**Oil Loss from the PDK Vent: Retrofitting Reservoir (69/22)**

Vehicle Type: **718 Cayman GTS 4.0 (982) / 718 Boxster GTS 4.0 (982) / 718 Cayman GT4 (982) / 718 Spyder (982)**

Concerns: **PDK vent**

*Oil loss from PDK vent*

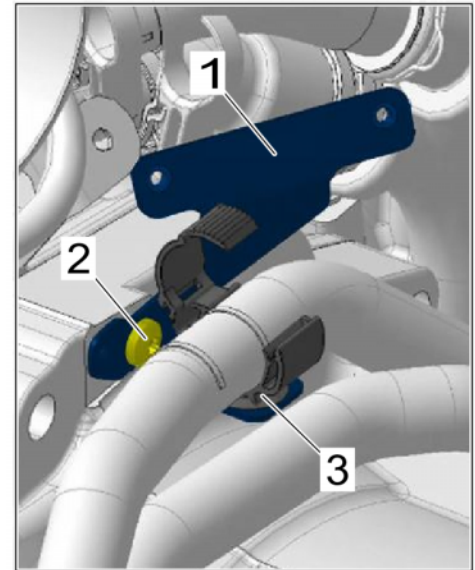
Information: Customers complain about oil loss from the double-clutch transmission (PDK) - particularly after sporty driving or after driving the vehicle on a race circuit. This can be caused by extreme centrifugal forces, which in unfavorable cases lead to oil leakage from the PDK vent.

Action: On vehicles from model year 2020 (L), retrofit the PDK vent reservoir. For instructions, see: ⇒ *Technical Information 'Retrofitting reservoir'*

*Retaining bracket*

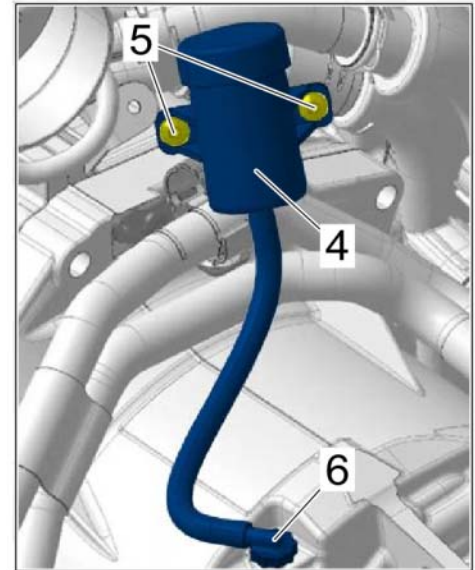
- 2 Tighten retaining bracket ⇒ *Retaining bracket -1-* with screw ⇒ *Retaining bracket -2-* on double-clutch transmission.

- 3 Clip coolant line clip ⇒ *Retaining bracket -3-* on the retaining bracket ⇒ *Retaining bracket -1-*.

*Reservoir*

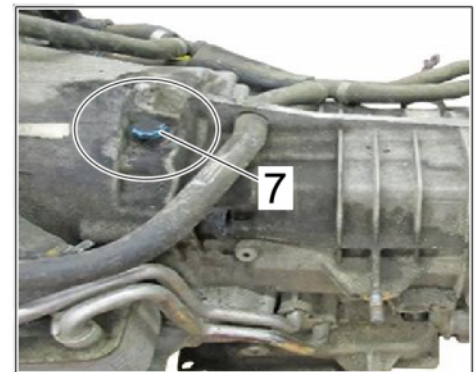
- 4 Fasten reservoir ⇒ *Reservoir -4-* to the retaining bracket ⇒ *Reservoir -5-* with screws ⇒ *Retaining bracket -1-* and tighten.
